s.16 Application No. A/K1/272
Proposed Minor Relaxation of Building Height and
Plot Ratio Restrictions for Permitted Hotel Use
at Kowloon Inland Lot No. 6022 S.B RP, 16 Kimberley Road, Tsim Sha Tsui, Kowloon
Further Information (responses to various departmental comments)

s.16 Application No. A/K1/272

Proposed Minor Relaxation of Building Height and Plot Ratio Restrictions for Permitted Hotel Use

at Kowloon Inland Lot No. 6022 S.B RP, 16 Kimberley Road, Tsim Sha Tsui, Kowloon

DRAWING TITLE	SIGHTLINE ANALYSIS OF PROPOSED VEHICULAR ACCESS
DRAWING NO.	FIGURE 5.1
REV.	A

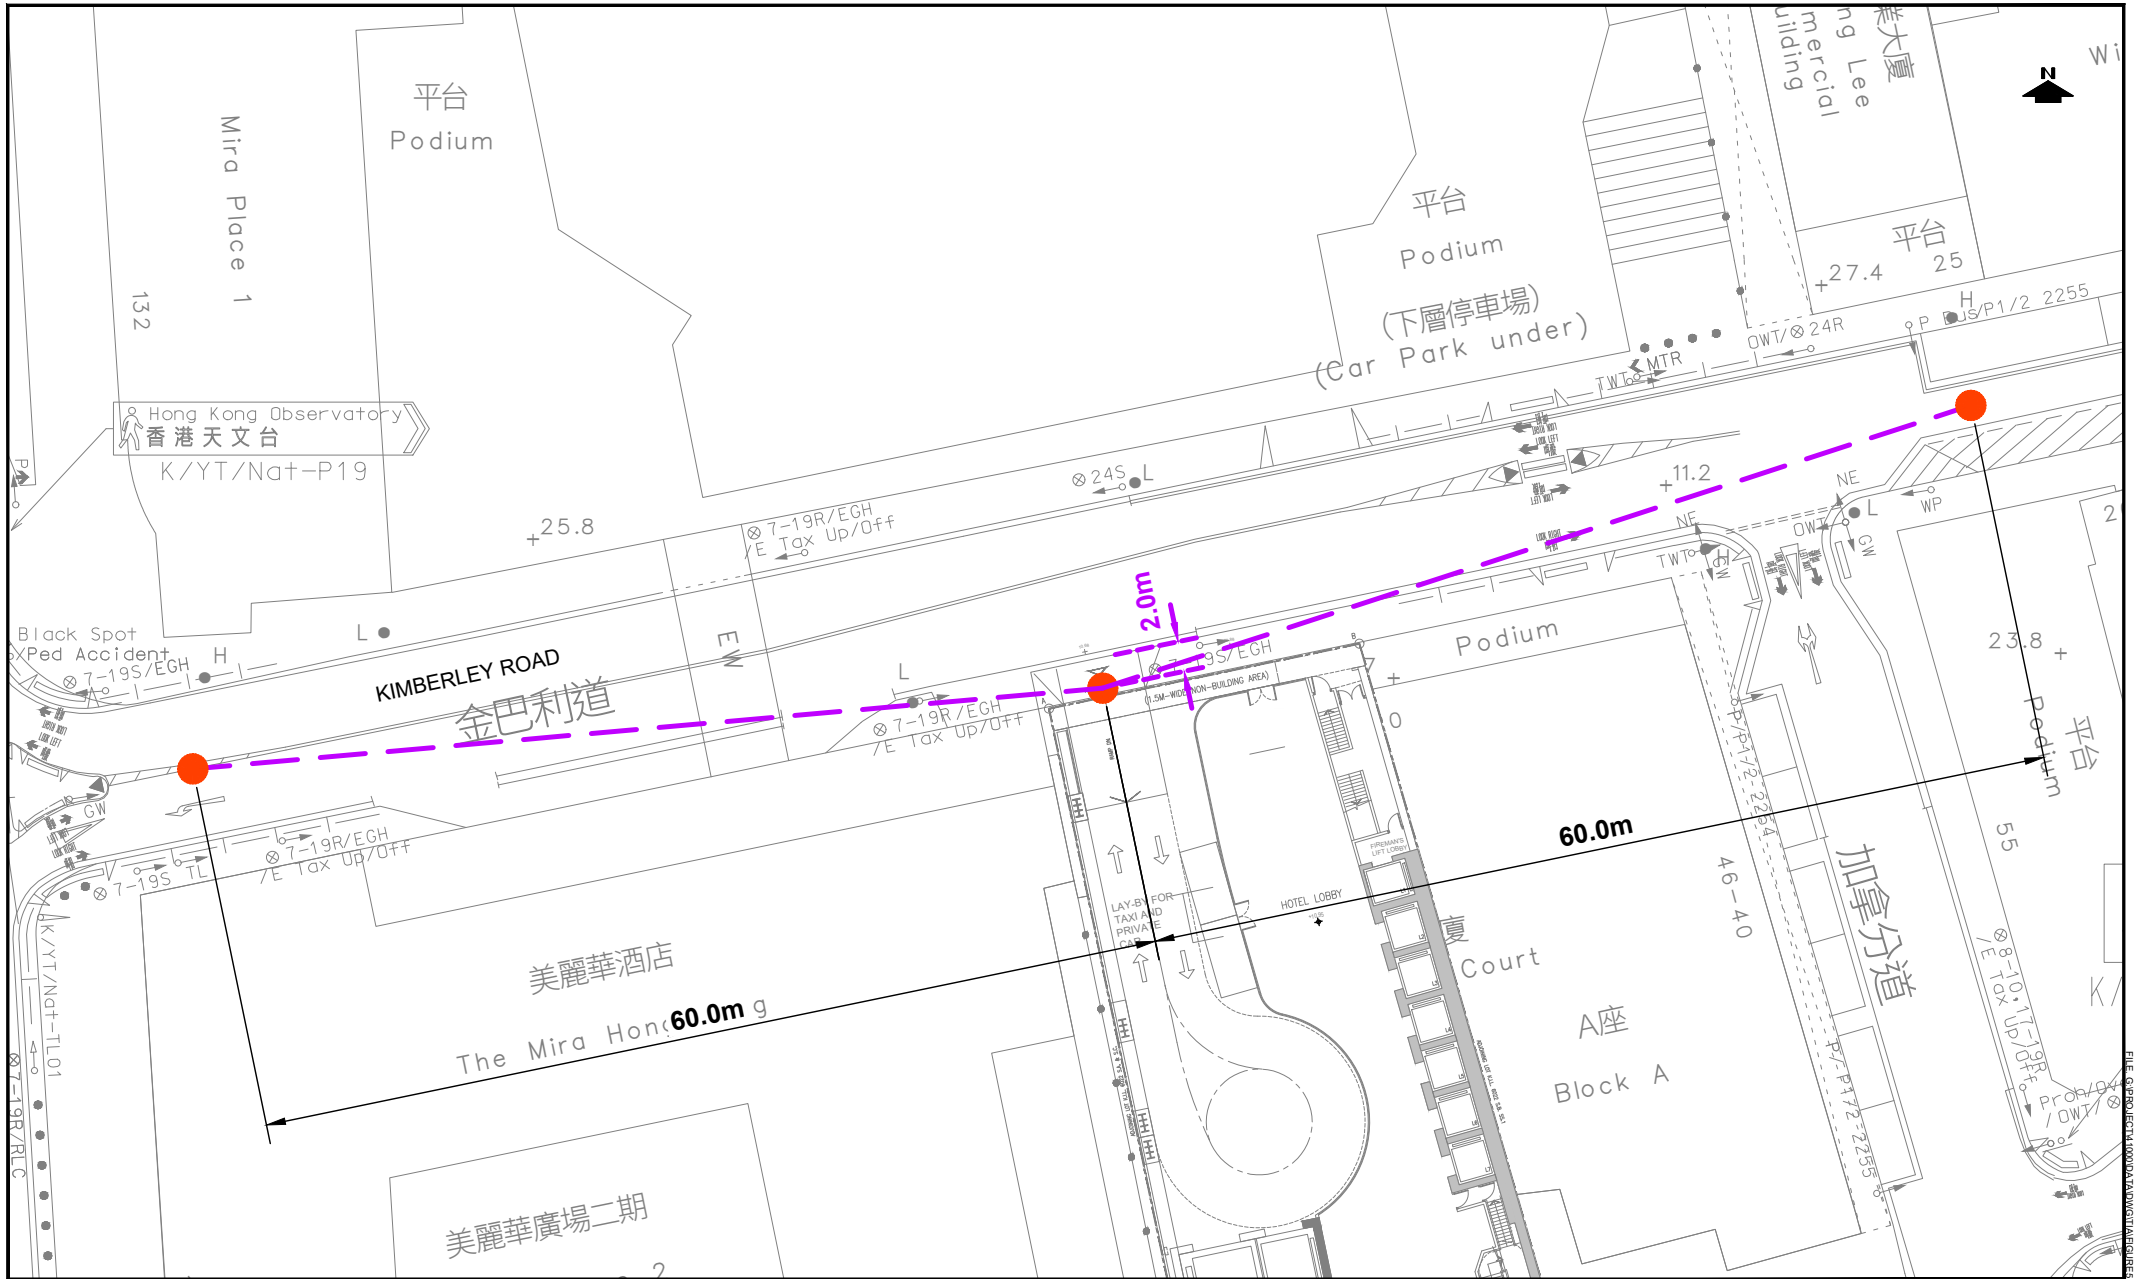
(i) Section 3.3 – Please assess the traffic impact resulted from the proposed development instead of just comparing to the previous scheme;	Noted. Traffic impact assessment is carried out and is in Section 4 of the updated TIA in Appendix A . No significant adverse traffic impact to the surrounding road junctions is anticipated.
(ii) Please elaborate the reason of changing from vehicular ramp in the previous scheme to car lift;	Noted. The type and dimension of car park spaces, loading/unloading area, car lift, width of access road are marked on the drawings accordingly (Appendix A).
(iii) Appendix A – Please specify the type and dimension of car park spaces, loading unloading area, car lift, width of access road on the drawings;	According to Table 2.2.2.1 in Volume 2 of the TPDM, the design dimensions of private car is 4.6m(L) x 1.7m(W). As a result, a larger vehicle size of 5.0m(L) x 1.79m(W) is representable and all swept path diagrams are reviewed and updated accordingly in Appendix A .
